**Canova Tech**

## **PLCA Corner-case Fixes**

**Feb, 23<sup>rd</sup> 2022**

PLCA Control State Diagram, part a

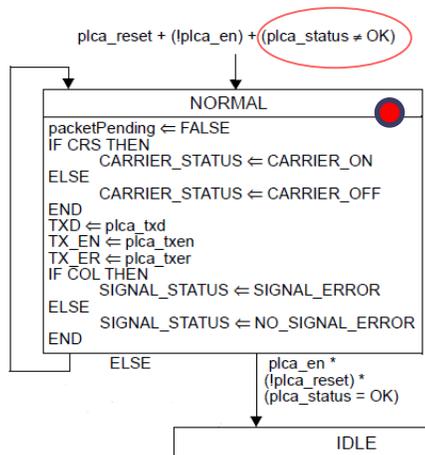
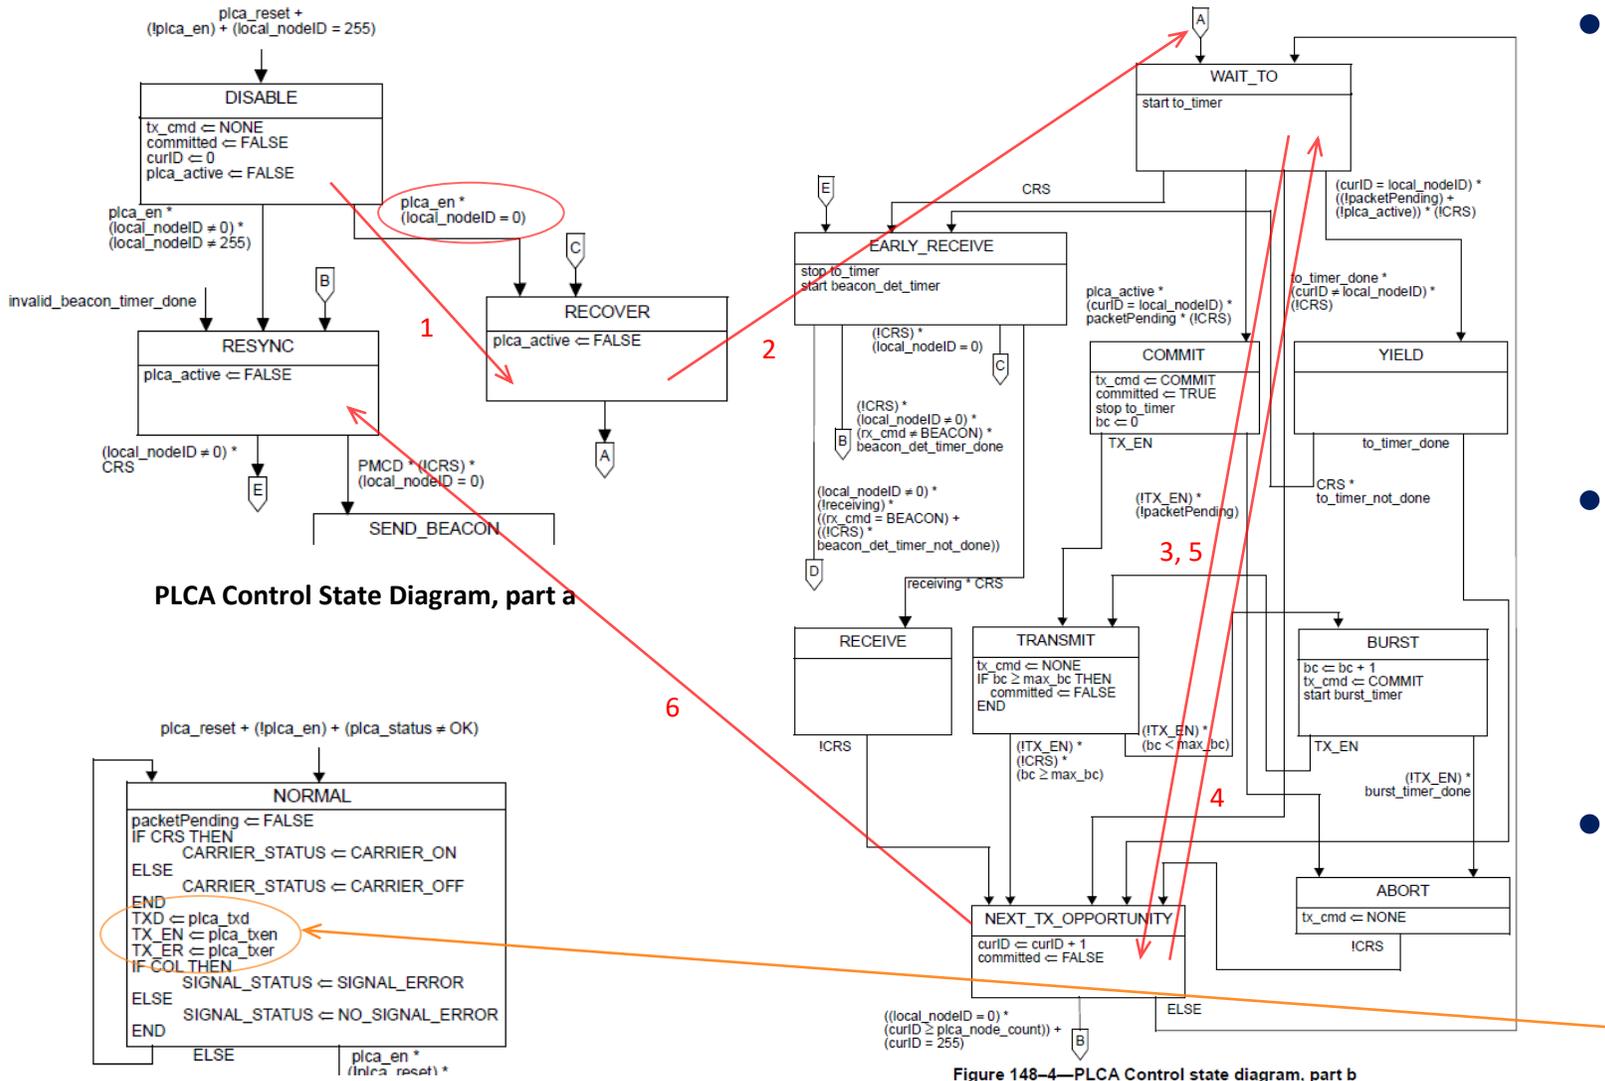
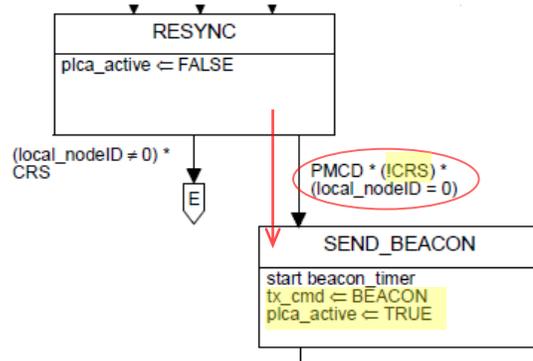
- Assuming the coordinator node ( $\text{local\_nodeID} = 0$ ) has PLCA enabled ( $\text{plca\_en} = \text{TRUE}$ ) but no BEACON has been sent so far ( $\text{plca\_status} = \text{FAIL}$ )
  - This may happen when enabling PLCA on-the-fly
- Because of  $\text{plca\_status}$  being FAIL, the PLCA DATA State Diagram is stuck in NORMAL state
  - That is, “plain” CSMA/CD behavior

- The PLCA Control State Diagram moves through RECOVER and WAIT\_TO states (1, 2) then waits for one cycle of TOs (repeat 3, 4) before entering RESYNC state (5, 6)
- Note that during this time, `plca_active = FALSE`, hence `plca_status = FAIL`
- If the MAC initiates a frame transmission at this time, it would be sent immediately (provided that CRS allows it)

- The problem shows up if the aforementioned frame is sent a few bit times before the PLCA Control state diagram enters the RESYNC state
- In such a case, the CRS would not yet be asserted due to the MII and PHY latencies, therefore letting the PLCA Control state diagram go to SEND\_BEACON state
  - This makes the PLCA Data state diagram move to IDLE state (because `plca_active = TRUE`, `plca_status = OK`)
- In IDLE state, the frame data coming from the MAC is overwritten by `tx_cmd` being set to BEACON
  - The frame gets corrupted at the MII (!)

Figure 148-4—PLCA Control state diagram, part b

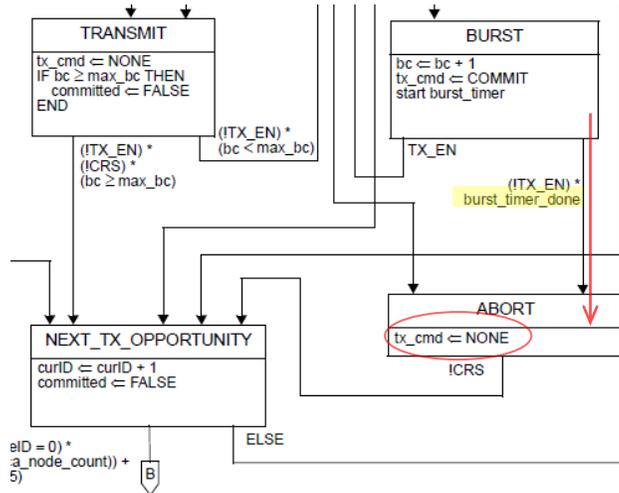
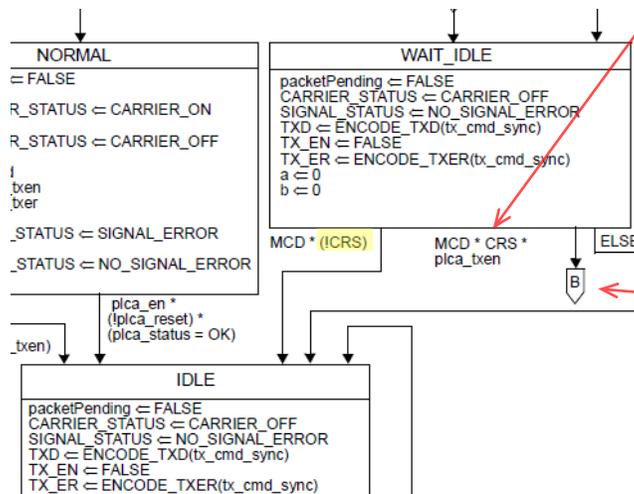
- When PLCA burst mode is activated ( $\text{max\_bc} > 0$ ), the PLCA RS waits the MAC to send a new frame for the duration of “burst\_timer” before moving to the next transmit opportunity.
  - During this time, a COMMIT is conveyed to the PHY to “keep” the current TO by extending the carrier ( $\text{CRS} = \text{TRUE}$ ).
- If the MAC conveys a new frame while the burst\_timer is active, the burst succeeds and the PLCA RS forwards the frame to the PHY via MII (appended to the COMMIT)
- else (i.e. the MAC has no further frames to send), the PLCA RS aborts the burst and moves to the next TO
  - If the MAC initiates a frame transmission ( $\text{plca\_txen} = \text{TRUE}$ ) concurrently with the burst\_timer expiration, the PLCA RS is **supposed** to just act as normal, delaying the frame until the next TO...
    - **BUT there's a race condition in the state diagrams!**

- When the burst\_timer expires, the PLCA Control State Diagram goes from BURST to ABORT state.
- Meanwhile, the PLCA Data state diagram is waiting in WAIT\_IDLE state for the MAC to send a new frame (plca\_txen = TRUE) or the burst to be aborted (CRS going low due to tx\_cmd being set to NONE)
- However, if the MAC starts conveying a frame a few bit times after the burst was aborted (before MCD), the PLCA Data state diagram would take the path of the successful burst “B” while the PLCA Control state diagram already aborted the burst (!)
  - This may lead to the frame being corrupted and to unwanted collision on the line

PLCA DATA State Diagram, part a

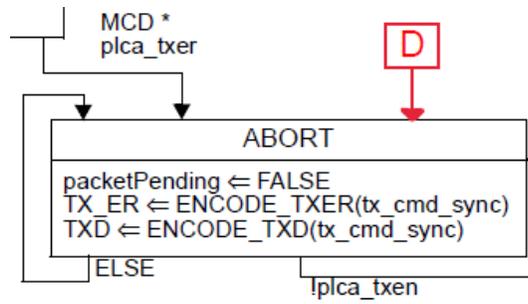
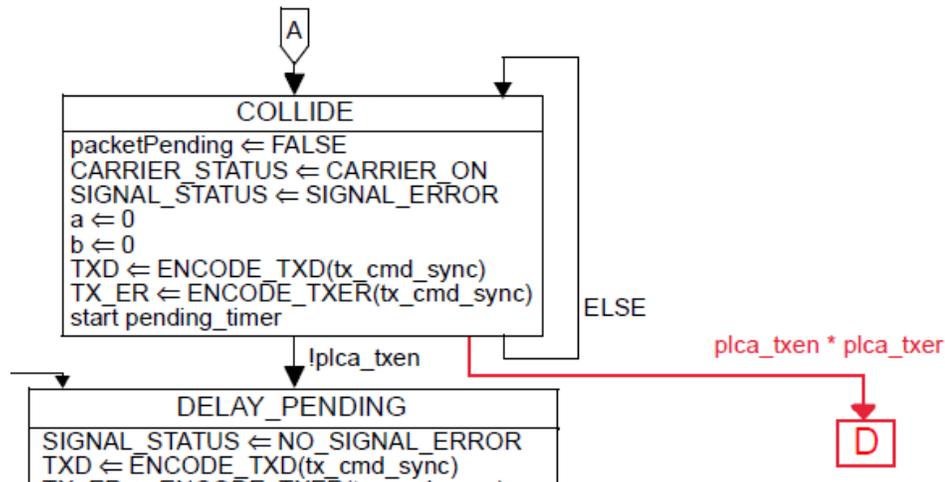
- The PLCA RS detects collisions by both monitoring the COL signal from the PHY and checking transmissions vs transmit opportunities
- In the latter case, the PLCA RS relies on the MAC to backoff and make a new attempt at sending the frame after the carrier indication goes off
- If the upper layers aborted the frame concurrently with the PLCA RS detecting a collision (very rare race), the next transmit opportunity may be skipped, leading to wasted bandwidth and/or multiple collisions

- A simple fix is to check the already existing `plca_txer` variable while the PLCA Data State Diagram is in the COLLIDE state.
- If `plca_txer` is set, just go into ABORT state, letting the PLCA RS serve the next TO without setting `packetPending` to TRUE
